HIGHLANDS COUNTY BOARD OF COUNTY
COMMISSIONERS (HCBCC)
PURCHASING DIVISION
600 S. Commerce Ave
Sebring, FL 33870
(863) 402-6500

BID NO. ITB 22-013-LKD ADDENDUM No. 2

Project.: Traffic Operations Building

MECHANICAL PLAN
 SCALE: 3/16"=1'-0"

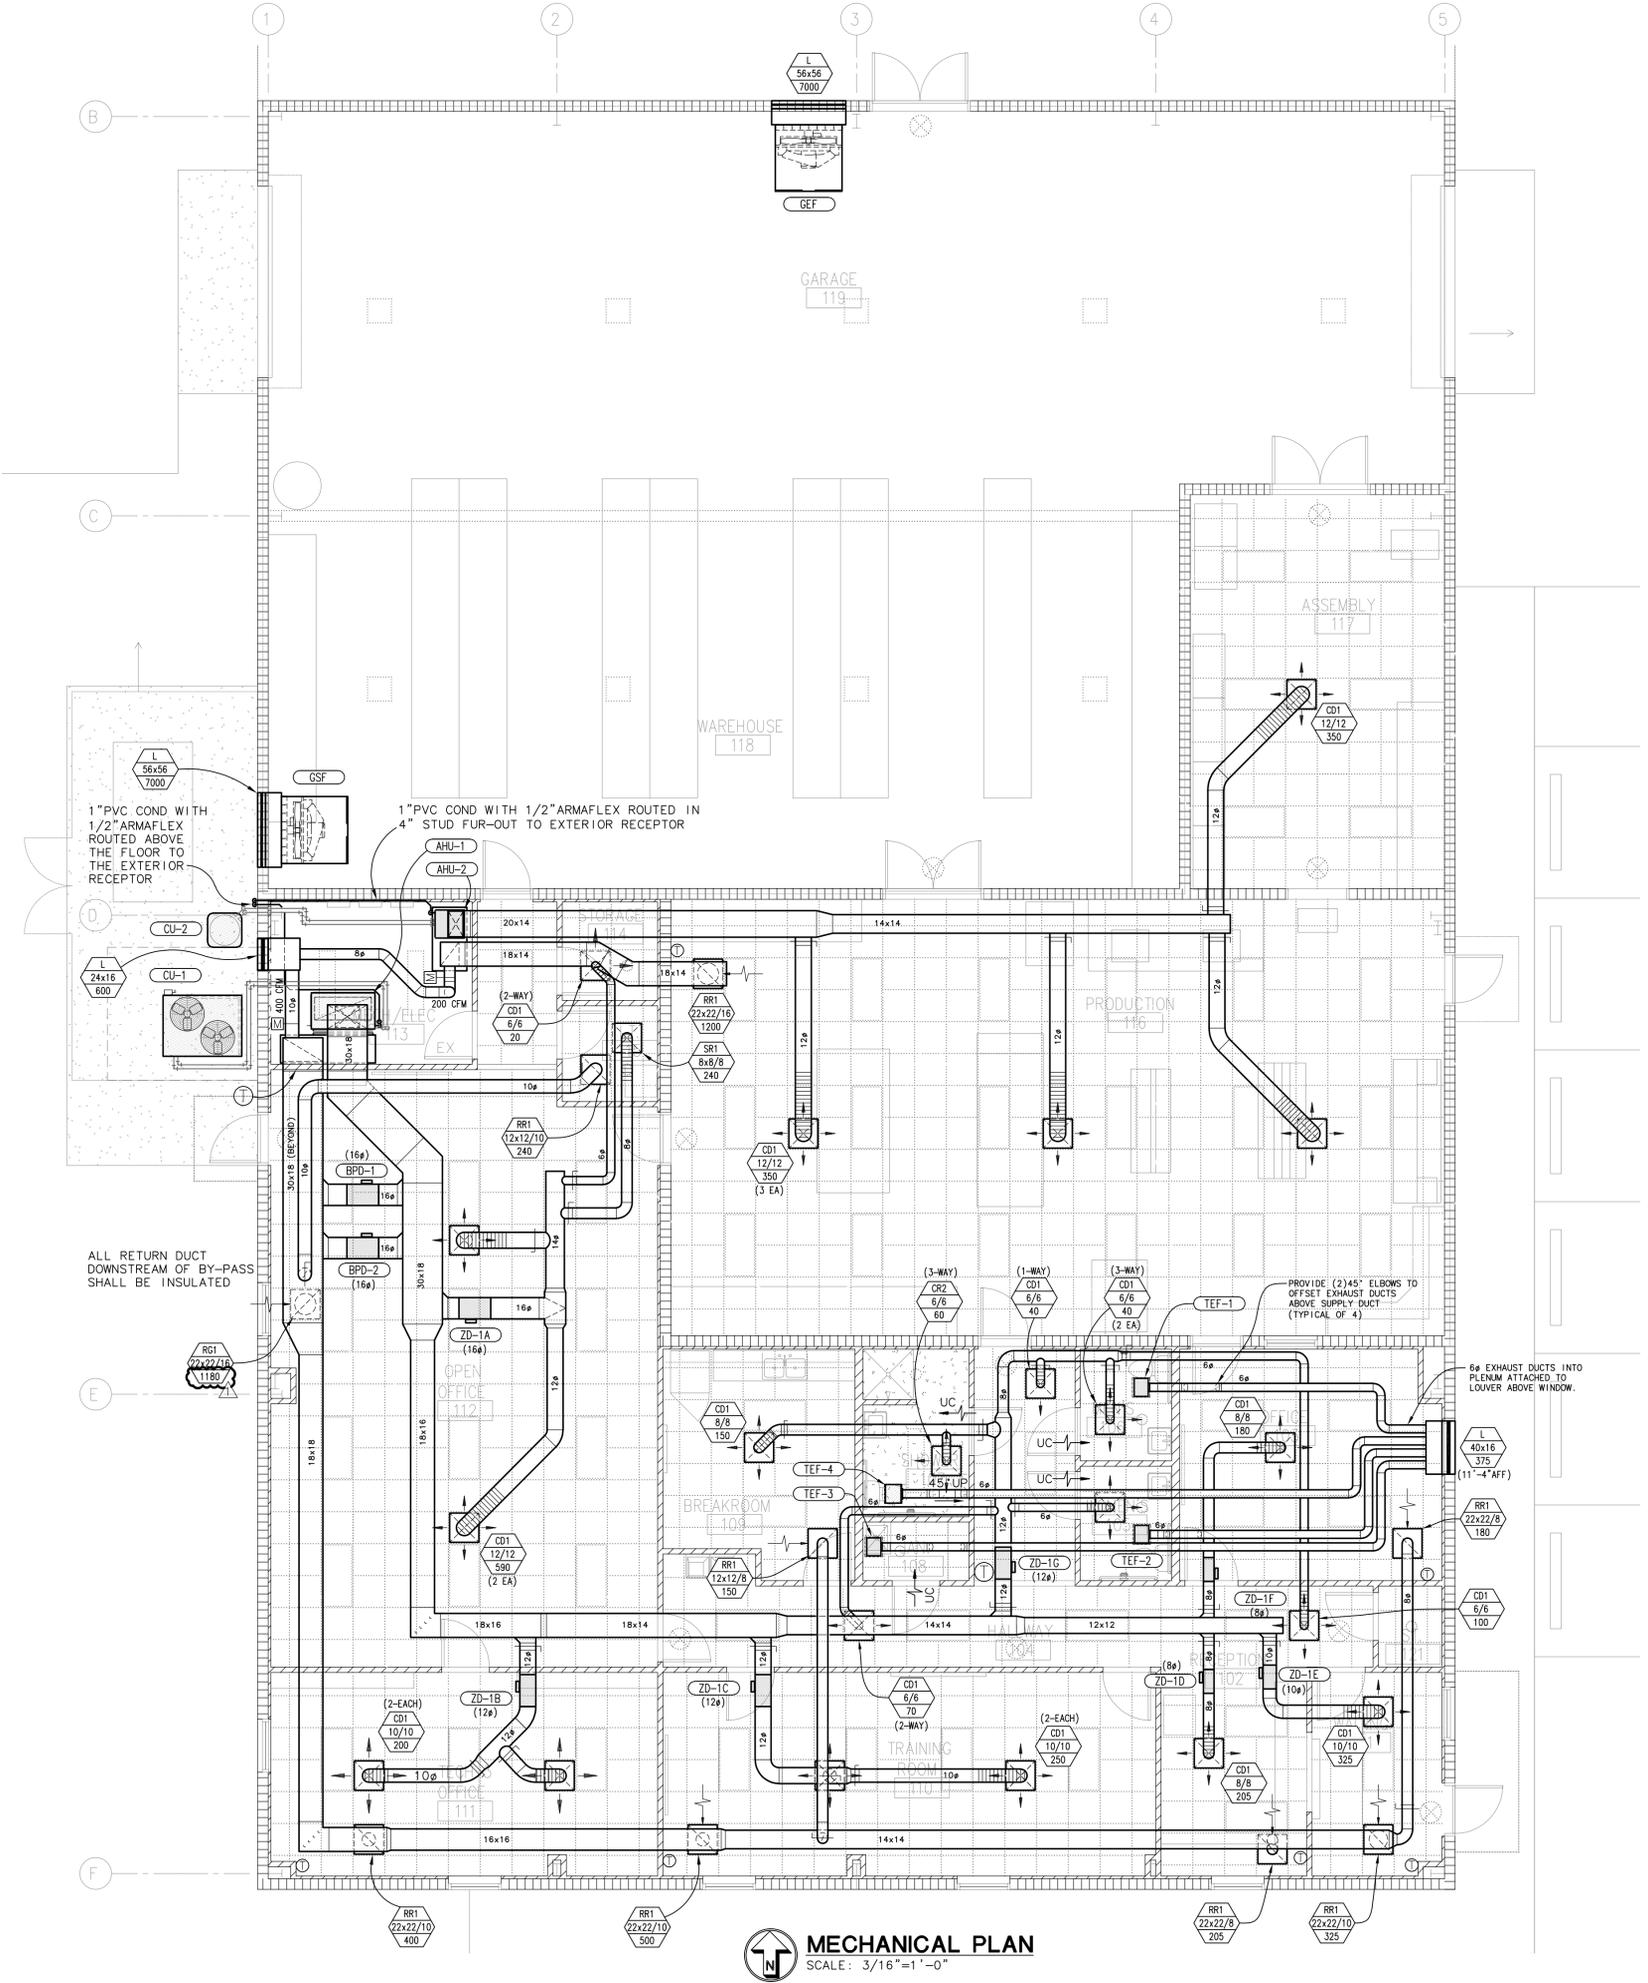
Q13	On Mechanical Pages- No zoning info provided. Please advise.
A13	We typically do not schedule VVT zone dampers. Their size is based on their connecting ductwork. Please see the VVT Detail on M-200 for more information.
Q14	On Mechanical Pages- No cfm requirements or register specs provided. Please advise.
A14	In the Air Distribution Schedule on M-100, the Legend notes that the third row of each air device tag lists the CFM. We did miss identifying the return CFM for Open Office 112. This has been corrected on drawing sheet M100.
Q15	2.02, D4 - Cabinet backs and unfinished surfaces need one coat of aluminum paint, is this required?
A15	Aluminum paint is not required.

AIR HANDLING UNIT DETAIL

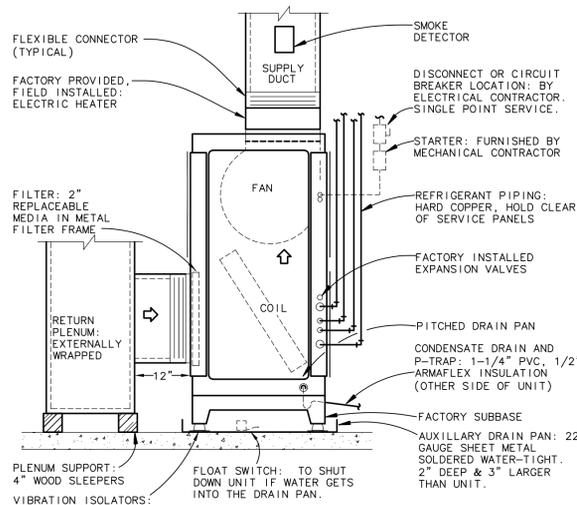
A8	The (5) type 'G' fixtures under covered storage shall now be connected to the <u>unswitched</u> leg exterior lighting circuit. All (5) fixtures shall now have motion sensor option #MSWL20. Remove wall mounted override switch (note #4).
Q9	The Specifications call for a flagpole, but the civil and architectural plans do not show one. Please advise.
A9	Delete the flagpole from the specifications.
Q10	Will Star Building Systems be an acceptable manufacturer for metal building systems in addition to those listed in Specification 13125, Part 2.01 A? I have attached specification data for Star Building Systems.
A10	We take no exception to this manufacturer.
Q11	Can a specification be provided for Shower stall and fixtures at Shower 107?
A11	Shower spec has been added to the Plumbing Fixture Schedule on P-300 (attached).
Q12	On Mechanical Pages- No equipment tonnage info provided. Please advise.
A12	"Nominal Tons" has been added to the schedule for AHU-1 on M-200 (attached).

DESIGNATION AREA SERVED	AHU-1 PERIMETER OFFICES
CARRIER MODEL NUMBER	40RUA12
WEIGHT - LBS	425
NOMINAL TONS	10
SENSIBLE CAPACITY - MBH (GROSS AT ARI CONDITIONS)	116.6
ELECTRIC HEAT - KW @ 240	10.0
ELECTRIC HEATER VOLTAGE	208/3
HEATER AMPS	20.8
FAN BRAKE HORSEPOWER	2.4
SUPPLY AIR CFM	3500
OUTSIDE AIR CFM	400
EXTERNAL STATIC PRESSURE	0.8
FAN MOTOR VOLTAGE	208/3
FAN MOTOR FLA	7.1
SPEED - RPM	879
MINIMUM CIRCUIT AMPS	34.9
FUSE/CIRCUIT BREAKER AMPS	35
REFRIGERANT PIPING SIZES:	
LIQUID	1-1/8"
SUCTION	5/8"
